# Agenda Item 5

PLANNING COMMITTEE Thursday 09 July 2020

# - ADDENDUM TO AGENDA -

#### Item 5.1 – 19 Downsview Road

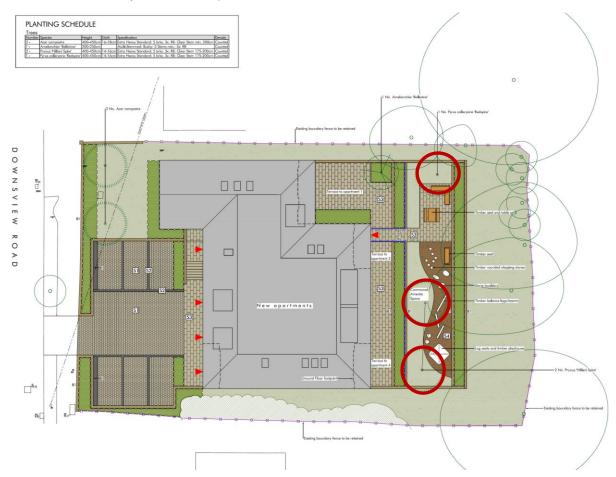
Amendments made to landscaping scheme and additional details/sectional plans of tree planting have been provided. These (primarily) constitute the planting of 3 additional trees within in consultation with the Council Tree Officer. Additional Trees are shown circled in red on the amended landscaping plan below (more details will be on committee presentation).
